July 27, 2000

00V-204 (01)

**SUBJECT: Recall Campaign 00724  
1996, 1997, 1998, 1999, 2000 Discovery & 1999, 2000 Bounder Diesel  
Power Steering Hydraulic Hose Routing**

Primary Description: 3/8" HOSE MENDER BARB

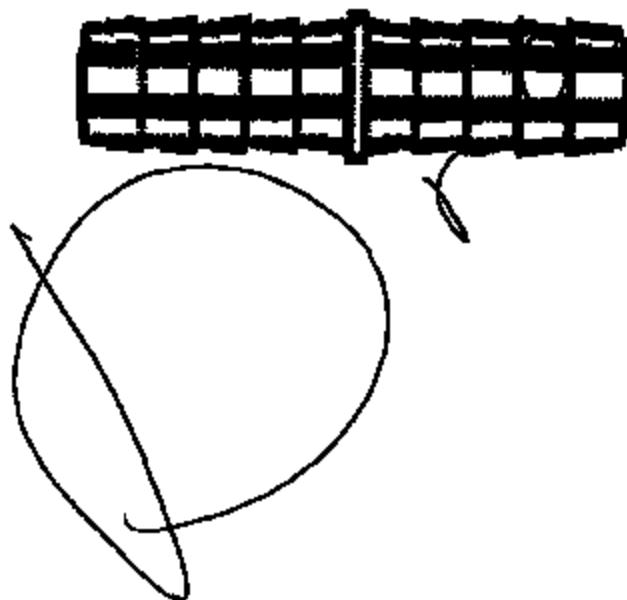
After the power steering return hose has been pulled back through the frame cross member, cut 1 inch on either side of the damaged area and install a 3/8 inch inside diameter brass barbed hose mender fitting or equivalent (See Illustration) using two 3/4 inch screw clamps. Go to step 4.
